South Texas Project Electric Generating Station P.O. Box 289 Wadsworth, Texas 77483

January 21, 2010  
U7-C-STP-NRC-100012

South Texas Project  
Units 3 and 4  
Docket Nos. 52-012 and 52-013  
Response to Request for Additional Information

**RAI 02.05.02-19, Supplement 2:****SUPPLEMENTAL QUESTION:**

**Figure 2.5S.2-39 Logarithmic Mean and Standard Deviation of Site Amplification Factors Transfer Functions (Amplification Factors) at Ground Surface from Analysis of the 60 Modified Random Profiles with the  $10^{-4}$  LF Input Motion**

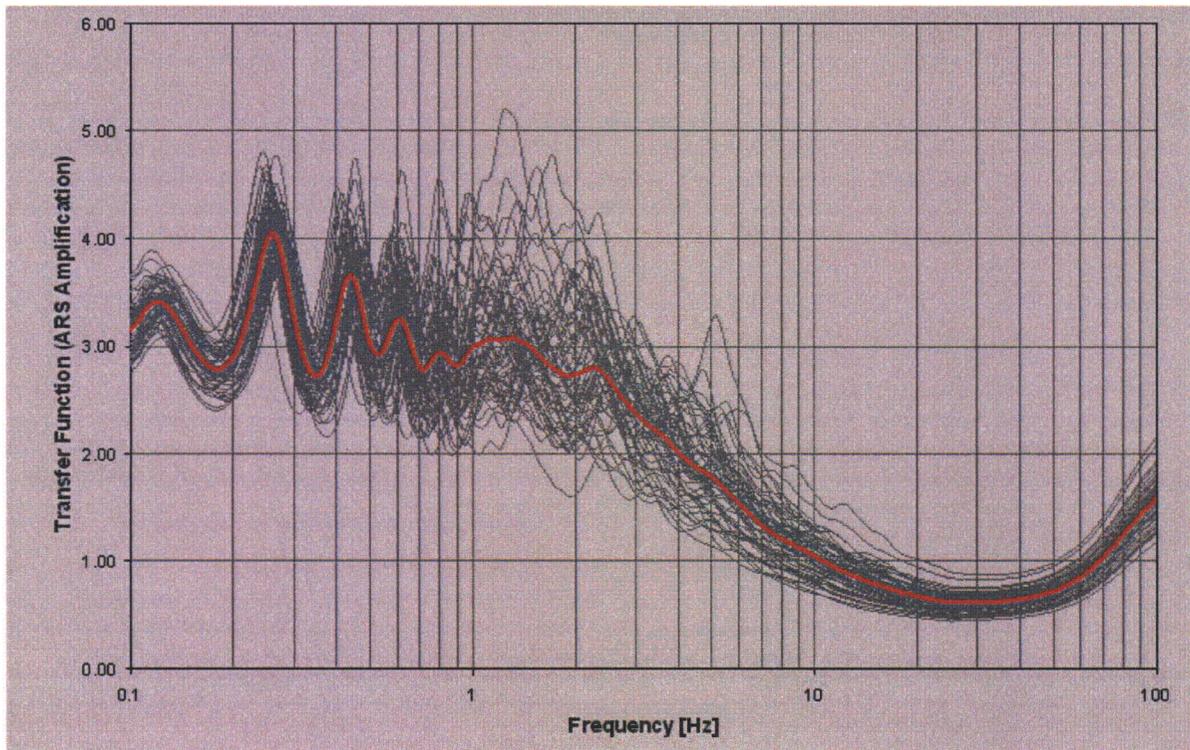
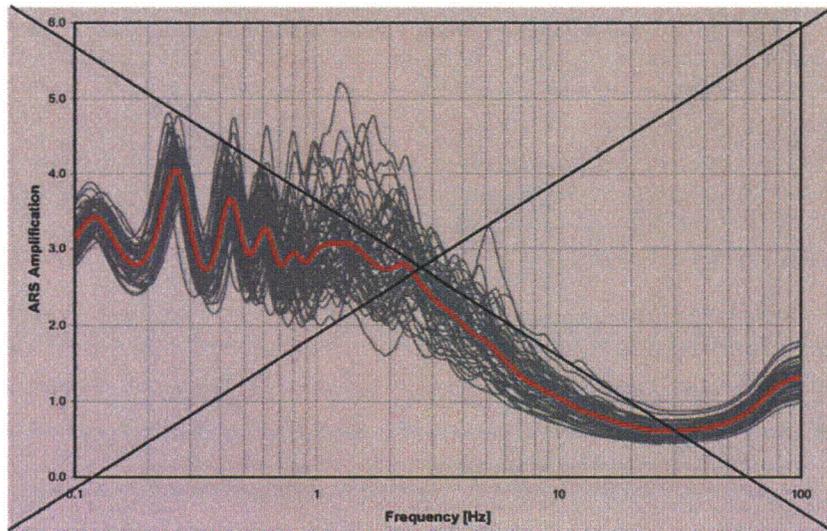
- a- new material parameters from newly available Resonant Shear Column Torsional (RCTS) test data;
  - b- deep sonic log data that resulted in changes in deep velocity profile; and
  - c- a truncation study that resulted in the soil column model being extended deeper.
- 2) During this review, STPNOC identified that FSAR Figures 2.5S.2-39, 2.5S.2-41, 2.5S.2-43, 2.5S.2-45 and 2.5S.2-49a should be revised to show the transfer functions consistent with the revised values in Tables 2.5S.2-18 and 2.5S.2-19.

FSAR Figures 2.5S.2-39, 2.5S.2-41, 2.5S.2-43, 2.5S.2-45 and 2.5S.2-49a will be replaced as shown on the following pages:
